Contract Change Order

Date: 07/21/15
Project No.: 2014-11
North Hancock
Road Extension
Location: Phase IIIA and IIIB
Contract No: 20150779
Change Order No.: 1

NAME OF PROJECT: North Hancock Road Extension Phase IIIA and IIIB
FINANCIAL PROJECT ID: 435515-1-58-01
LAKE COUNTY PROJECT NUMBER: 2014-11
NAME OF CONTRACTOR: Pospiech Contracting, Inc.
SUBJECT: Change Order No. 01 (CO-01)
DATE: July 9, 2015
FILE NO.: 6.0 (07-09-2015_CO-01)

SOLID POURED CONCRETE RETAINING WALL
WITH SPLIT FACE ARCHITECTURAL
BLOCK INSTALLATION
STA. 234+20 TO 236+40 (I.I.)
N.T.S.

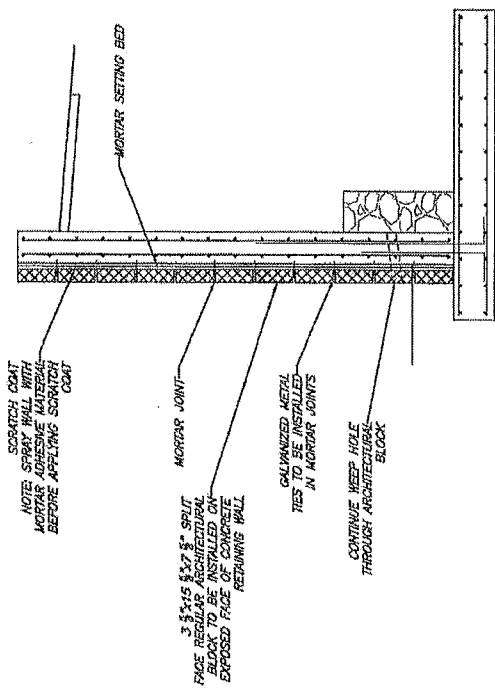
CO-01-04: Request For Proposal No. 02: This item contain two elements. First, pursuant to Lake County request Retaining Walls STA 233+30.44 to STA 236+20, Right and STA 234+20 to STA 236+40, Left are to be modified per revised plans provided (see attached Exhibit 4). Second, gravity walls at six locations are deleted from the Work at the following stations: (1) STA 205+40 to STA 206+25, Left; (2) STA 213+00 to 213+50, Left; (3) STA 226+00 to STA 226+20, Left; (4) STA 227+30 to STA 227+49.91, Left; (5) STA 229+40 to STA 229+60, Left; and STA 233+30.44 to STA 236+20, Right.

- NOTES:
1. WALL MUST BE CLEAN AND FREE FROM DIRT AND OTHER FOREIGN MATERIAL BEFORE INSTALLATION OF ARCHITECTURAL BLOCK.
 2. FOLLOW MANUFACTURER'S RECOMMENDATION FOR INSTALLATION OF ARCHITECTURAL BLOCK.
 3. CONTRACTOR TO PROVIDE SAMPLES OF PRODUCT PRIOR TO ORDERING.
 4. KEEP HOLES MUST BE COORDINATED IN THE INSTALLATION OF THE ARCHITECTURAL SPLIT FACE BLOCK.
